STATE SIGNIFICANT DEVELOPMENT MP09_0074 MOD 3 – RESPONSE TO ADDITIONAL COMMENTS ON THE RESPONSE TO SUBMISSIONS

SRC Operations Pty Ltd (SRC Operations), a wholly owned subsidiary of Bingo Industries Limited (Bingo), own and operate the Patons Lane Resource Recovery Centre and Landfill (PLRRCL) located at 123 - 179 Patons Lane, Orchard Hills, New South Wales (NSW) (the site). SRC Operations are seeking approval under Section 4.56 of the NSW Environmental Planning and Assessment Act 1979 (EP&A Act) to modify (the modification) State Significant Development (SSD) consent MP09_0074 (the consent) to:

Project	ALSPEC INDUSTRIAL BUSINESS PARK
Title	CONSTRUCTION STAGES PLAN

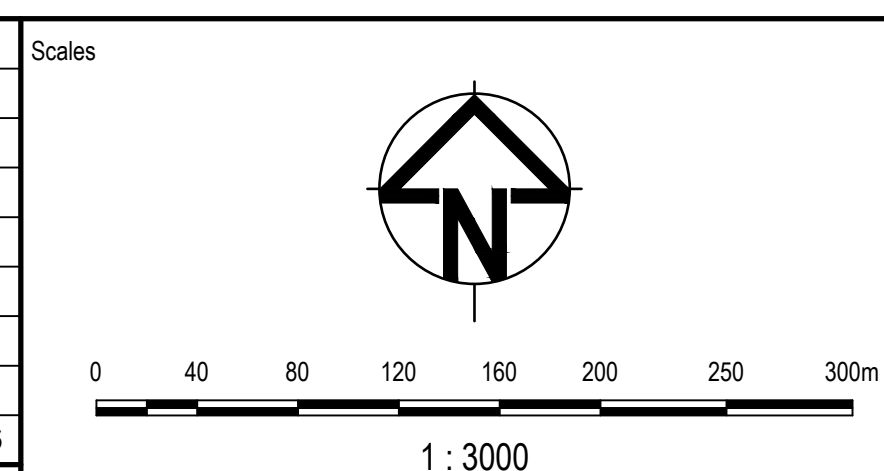
SRC Operations has undertaken additional consultation with AIBP to identify how traffic will be managed during their intersection upgrade works. AIBP have detailed that they will be staging the intersection upgrade to construct the carriageways offline. This will allow ongoing two-way traffic on Patons Lane during construction.

Any interruptions to two-way traffic flows to enable tie in's etcetera, would be minor, short term and managed through the use of dedicated traffic controllers.

The draft staging plan for the intersection upgrade works showing how the traffic flows on Patons Lane would be maintained, is provided at Attachment B. Note that construction of the proposed intersection upgrade is not yet approved and SRC Operations is not the proponent of that project.
